STAFF RECOMMENDATION
3542 Richland Avenue
Lot 19, Richland Hall Development
February 20, 2019

Application: New Construction—Infill
District: Richland-West End Neighborhood Conservation Zoning Overlay
Council District: 24
Map and Parcel Number: 104 09 0 304.00
Applicant: Chad Gore, Mike Ford Builders
Project Lead: Jenny Warren, jenny.warren@nashville.gov

<p>Description of Project: Application to construct a new single-family infill with an attached garage at basement level.</p> <p>Recommendation Summary: Staff recommends approval of the project with the following conditions:</p> <ol style="list-style-type: none">1. The finished floor height be consistent with the finished floor heights of neighboring historic houses, to be verified by MHZC staff in the field;2. Staff inspect the front setback during staking to ensure the setback's compatibility with the historic house at 3526 Richland Avenue and the new infill at both 3530 and 3534 Richland Avenue; and3. Staff approval of stone and brick samples, all windows and doors, the garage doors, the roof shingle color, the materials of the porch floor and steps, and the material of the driveway and walkway <p>With these conditions, staff f

Figure 3. The proposed footprints and setbacks for Lots 18-22 of the Richland Hall development.

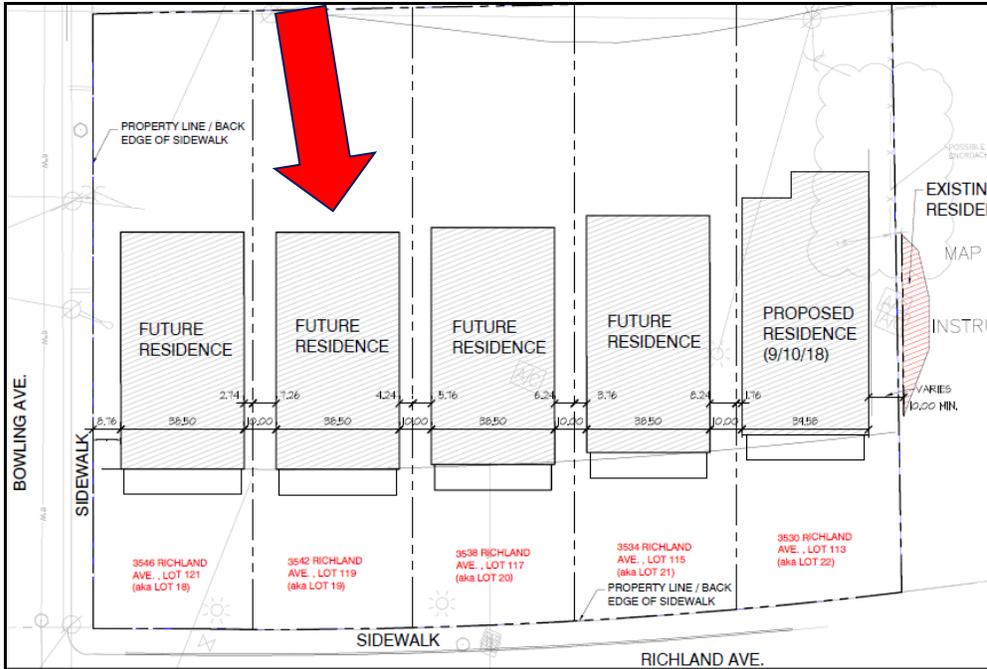
Setback & Rhythm of Spacing: This infill for Lot 20 of the Richland Hall development is the third house developed for this block. As such, it is helpful to look at the proposed setbacks of five infills proposed for this section of Richland Avenue.

The front setbacks for the five infills will gradually step back, matching the curve of Richland Avenue and transitioning the front setbacks to the historic house at 3526 Richland Avenue. The first infill, at 3530 Richland Avenue, lot 22, was approved to have a front setback of approximately fifty-eight feet, six inches (58'6"). This setback is similar to the front setback of the historic houses at 3526 Richland Avenue, when the curve is taken into account. The house two doors down at 3534 Richland Avenue (lot 21), was approved with a front setback of approximately fifty-eight feet, seven inches (58'7"), which again is consistent, considering the curve. The proposed infill at 3542 Richland (lot 19), is shown with a setback of approximately fifty-seven feet, eleven inches (57'11"). Given the curve, this appears to maintain the consistent setback. Staff recommends that the field staking be checked by MHZC staff in the field, to ensure that the proposed setback maintains the appropriate consistent setback shown in Figure 3.

The applicant is requesting a side setback determination for the right side. The existing house at 3526 Richland Avenue is shifted on the lot and sits less than two feet (2') from the shared side property line with the recently approved infill at 3530 Richland Avenue. Because of this and because the same developer owns all five of these lots, the applicant is proposing to shift all the infills in this section of the development. Four of the five infills will require an alteration to the base zoning setbacks, but all of the houses will have a minimum of ten feet (10') apart. The Commission approved a similar set of setbacks for Lots 1, 2, 3, 4, 5, 6, and 7 of this development.

The proposed infill at 3542 Richland, the infill being considered under this application, will be approximately seven feet (7') from the left side property line and approximately four feet, six inches (4'6") from the right side property line. The infill will be a minimum of ten feet (10') from the future infill houses on both sides, at 3538 Richland Avenue and 3546 Richland Avenue.

This property needs to be shifted on the lot to maintain the ten foot distance between it and the property to the immediate right, at 3546 Richland Avenue. The proposed house at 3546 sits at the corner of Bowling Avenue and Richland Avenue, and will be about eight feet, nine inches (8'9") from the Bowling Avenue property line and two feet, nine inches (2'9") from the right side property line. Because base zoning requires a ten foot (10') side setback along Bowling Avenue, this infill, when it is submitted, will need side setback determinations for both sides. The Commission has reduced a side street setback to less than ten feet (10') where there are nearby corner houses with side setbacks of less than ten feet (10') along the side street. In this case, other houses at this corner sit as close as seven feet, six inches (7'6") to the Bowling Avenue property line, so an eight foot, nine inch (8'9") side setback could be appropriate.

Because this lot is part of a larger development and because the reduced side setback will not affect an existing house, but rather a future house in this development, staff finds that the reduced left side setback meets the historic context and the design guidelines.

Staff finds that the proposed setbacks to be similar to the immediate historic context and to meet Section II.B.1.c. of the design guidelines.

Figure 4. Left Elevation

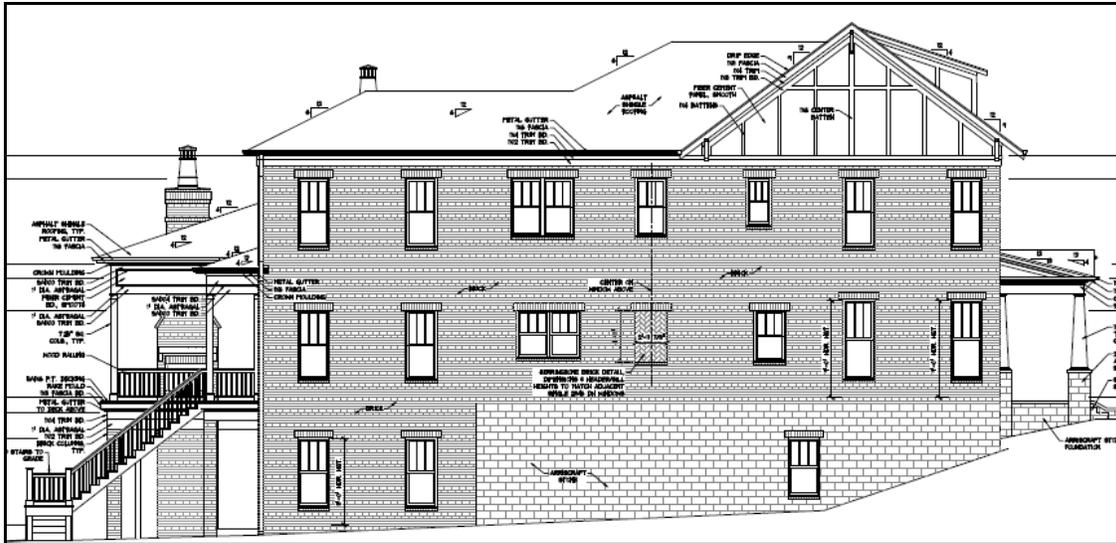
Roof form: The primary roof has a side-gabled roof form (9/12 slope) with a shed dormer (4/12 slope). The front porch has a projecting shed roof (3/12 slope) with a front gable over the entry. The roof hips in the back with 6/12 and 4/12 slopes. Staff finds that the roof forms are appropriate for an infill house in the overlay, and finds that the roof forms meet Section II.B.1.e. of the design guidelines.

C2
 SITE PLAN

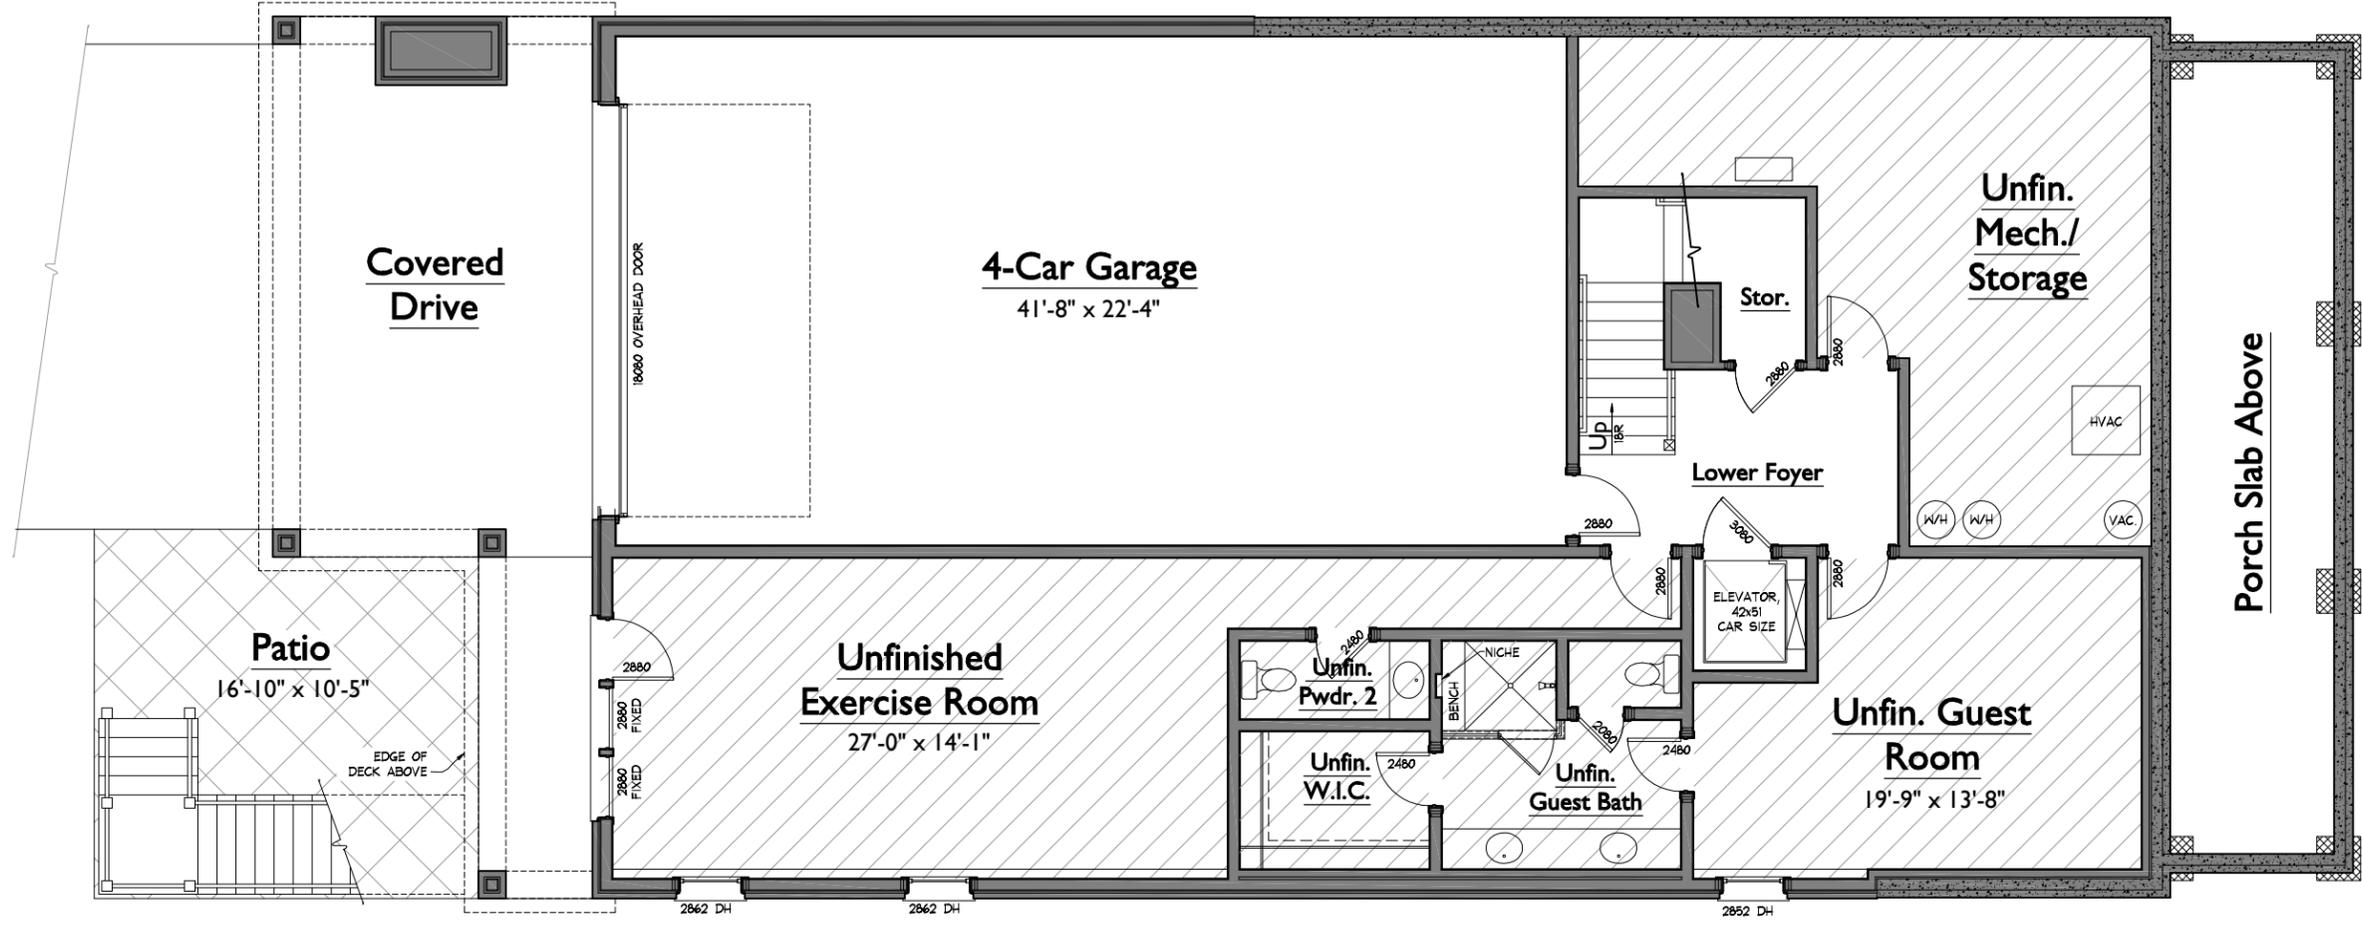
Because of the steep slope of the lot, the foundation height will vary from about two feet (2') on the front, to about ten feet (10') tall near the back of the infill. At the rear, a full height walk-out basement level will be clad in brick, rather than foundation material. Staff recommends inspection of the foundation and the finished floor height to ensure that the height of the foundation at the front is appropriate for the historic context.

Staff recommends verification of the construction height of the foundation and floor systems in the field to ensure that the finished floor line of the new construction is compatible with the historic context. With this condition, staff finds that the height and scale meet Section II.B.1.a and II.B.1.b of the design guidelines.
